Appln. No.: 09/919,998

Title: A SPARK PLUG AND A METHOD OF PRODUCING THE SAME

REQUEST FOR DRAWING CHANGE AUTHORIZATION

FIG. 2A

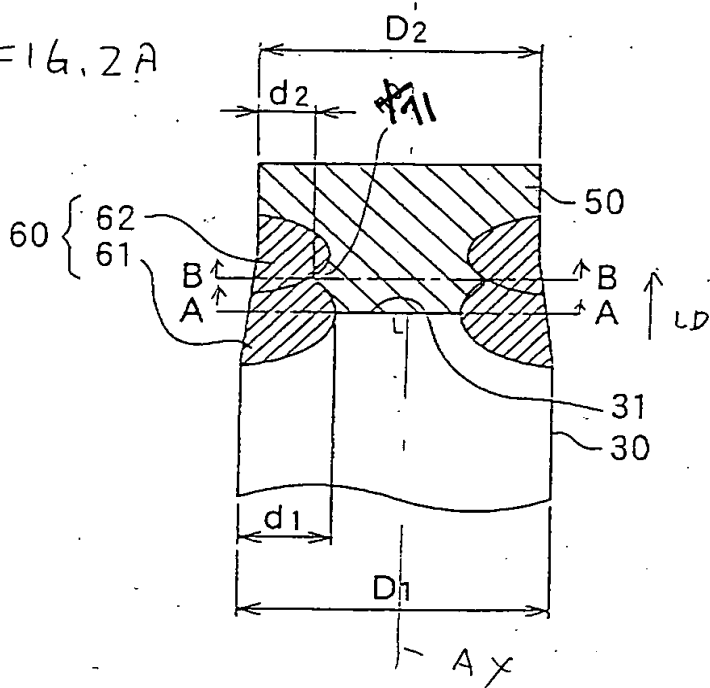
In other words, wedge portion [70] 71 of the chip projects into the weld portion 60. The second weld layer 62 catches this wedge portion 70. This prevents the chip 50 from being disconnected from the central electrode 30.

Submitted herewith is a copy of a drawing sheet containing Fig. 2A and Fig. 3 of the application drawings, showing proposed changes in red. Approval of these changes is requested.

FIG. 3

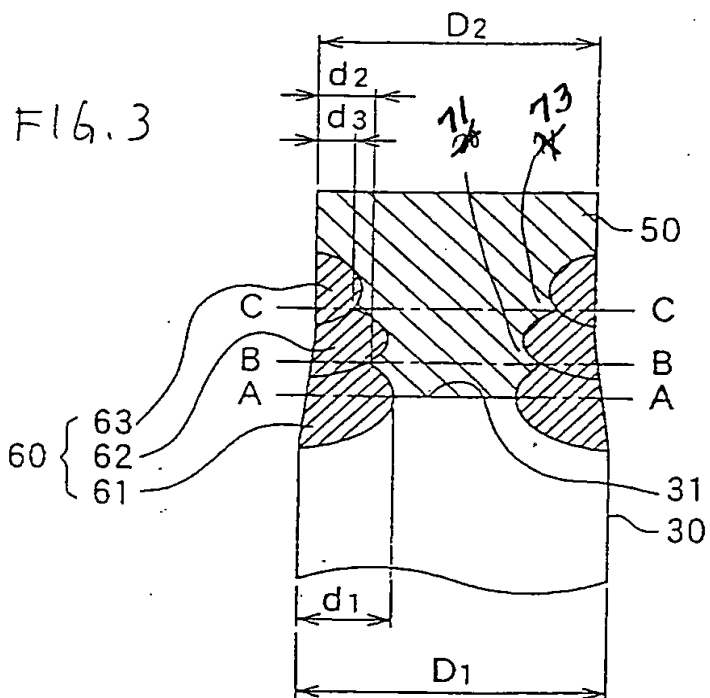
In the three-layer structure shown in Fig. 3, another wedge portion [71] 73 is further provided between the second and third weld layers 62 and 63. This provides a stronger wedge structure .
